DG 01 Existing double door
Sitting room elevation

DG 01 Proposed bi-fold door
Sitting room elevation

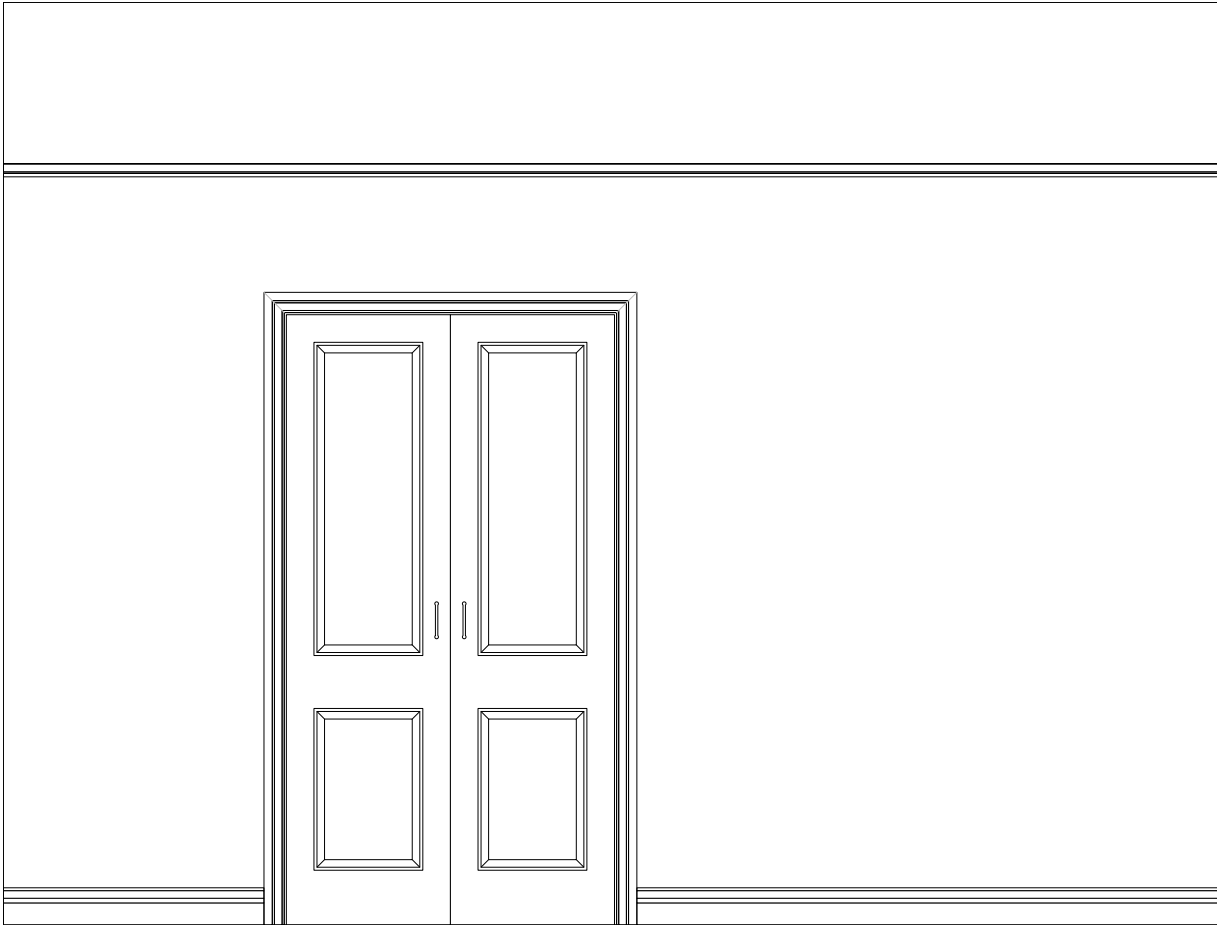
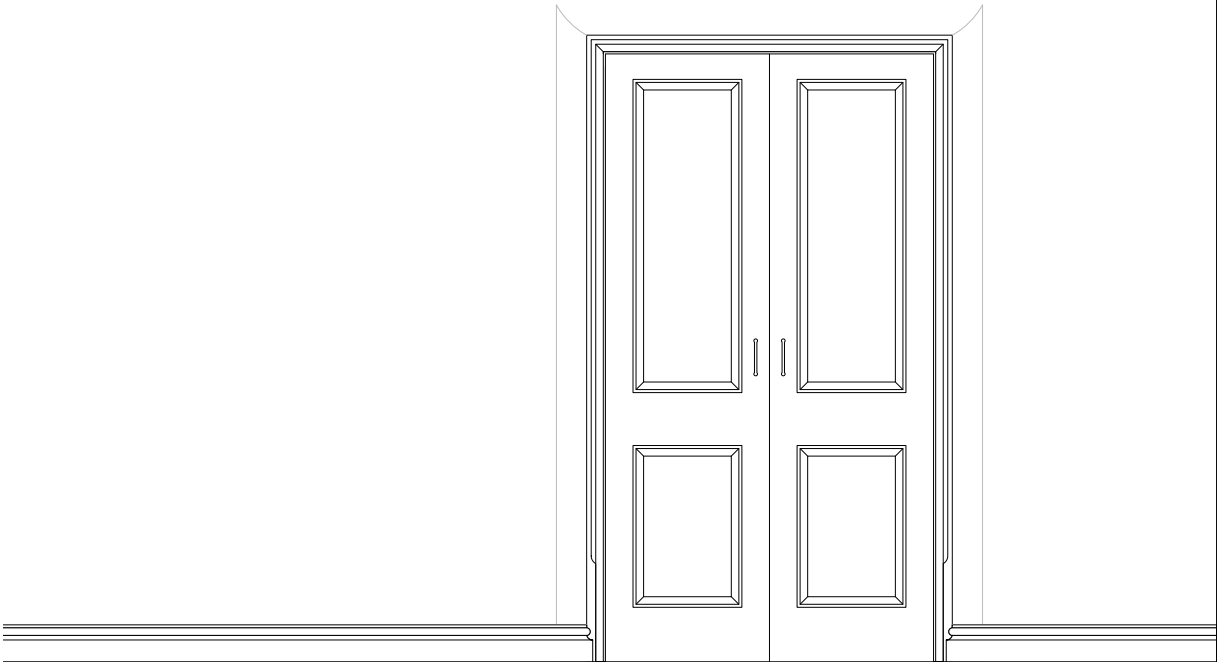
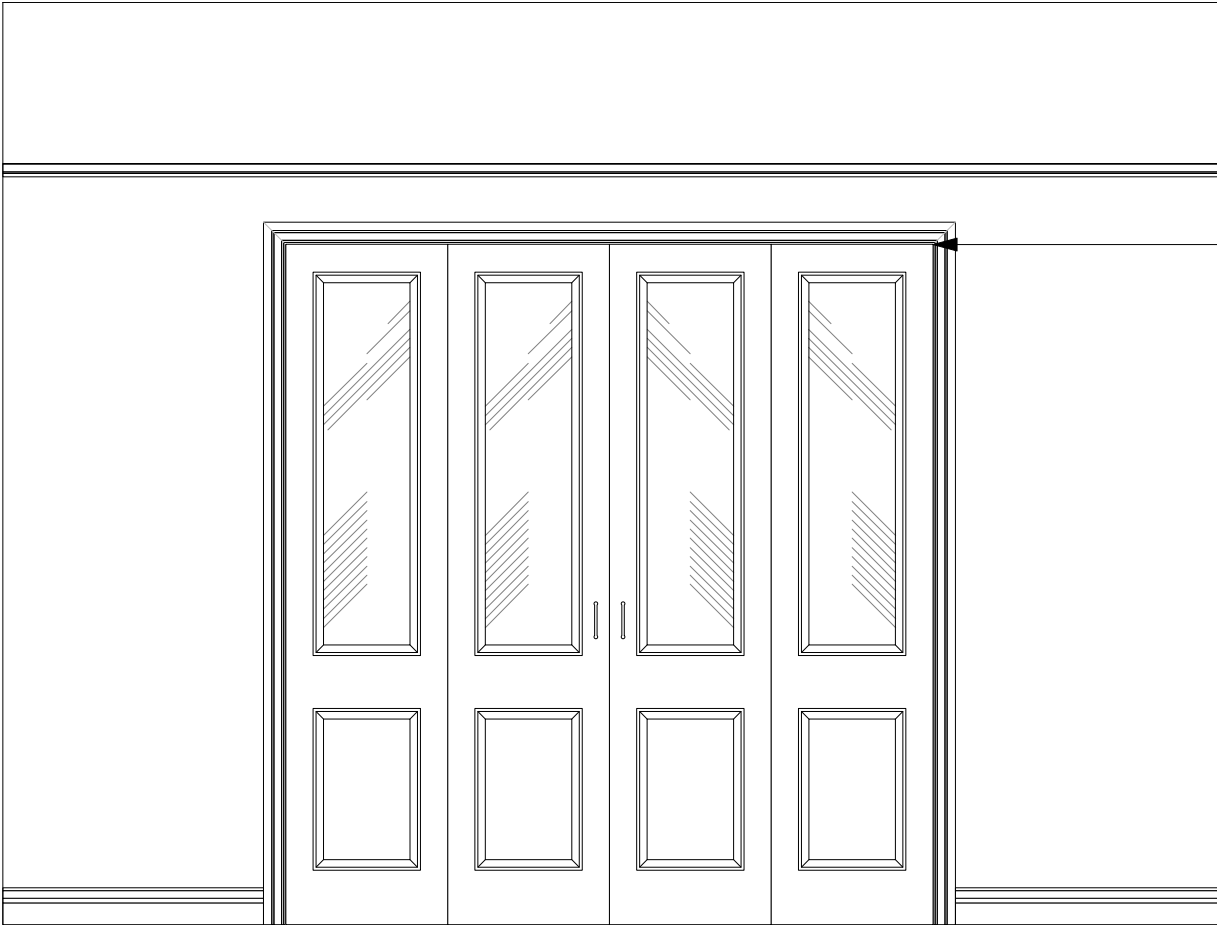
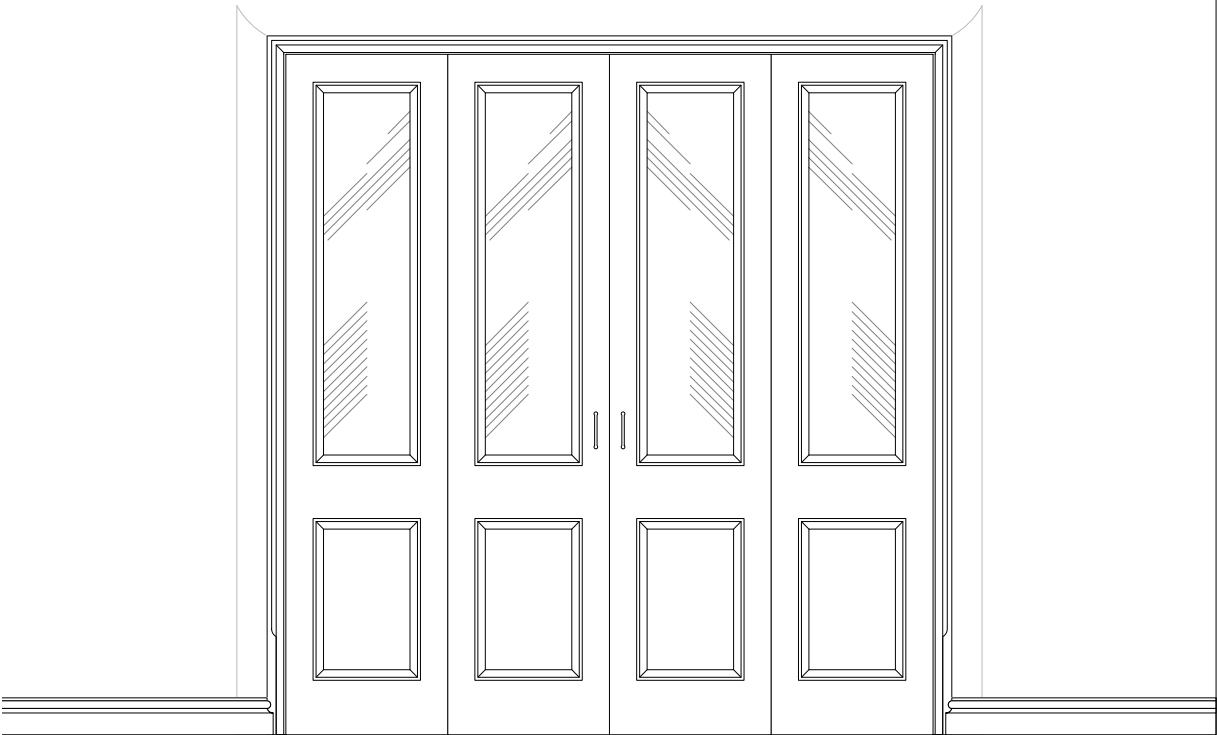
Door head height to be increased to allow 150mm wall clearance below existing picture rail. Existing reveal detail & door profile to be replicated in proposed. Top panels to be clear glazed.
